PRELIMINARY DRAINAGE REPORT

ROLLIN RIDGE ESTATES

April 30, 2018
Revised August 30, 2018
Revised October 19, 2018

JPS Project No. 081702
PCD File Nos.: SP-18-001, PUD-18-003, & P-18-001

SHEET: **D1.1**

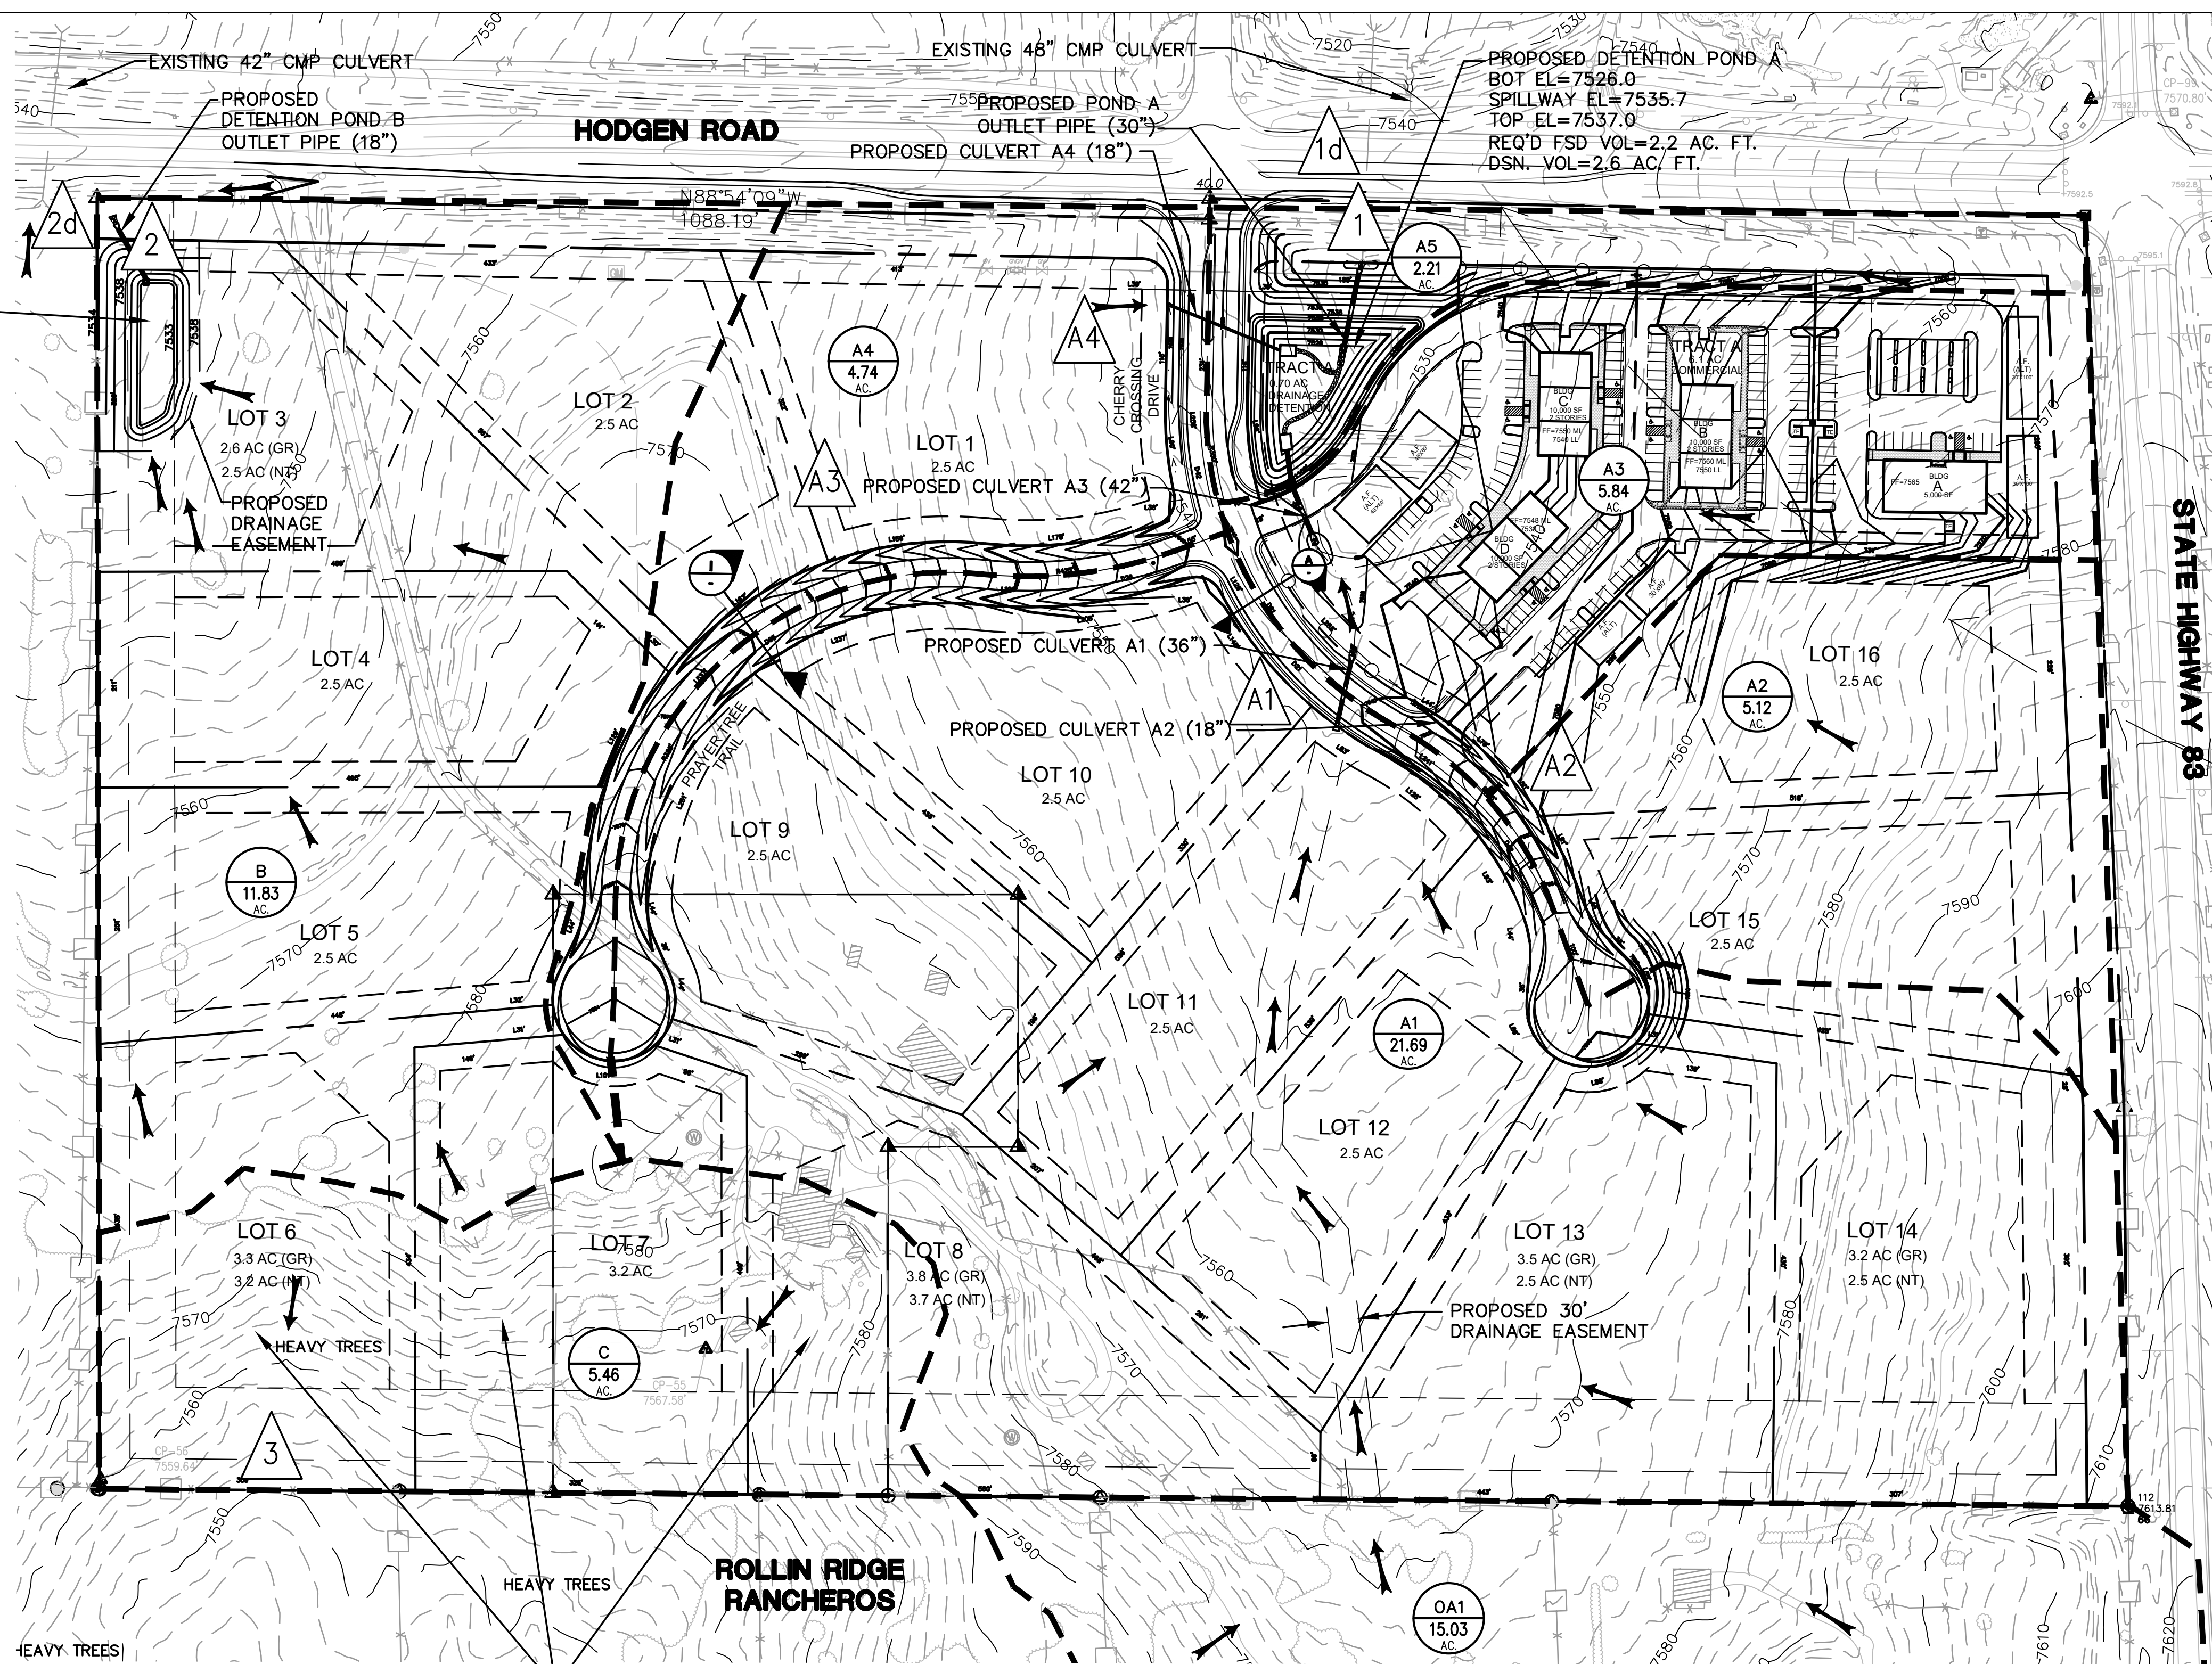
Basins B and OB1 drain to the proposed Full Spectrum Detention Pond B, not Pond A. Please correct this paragraph.
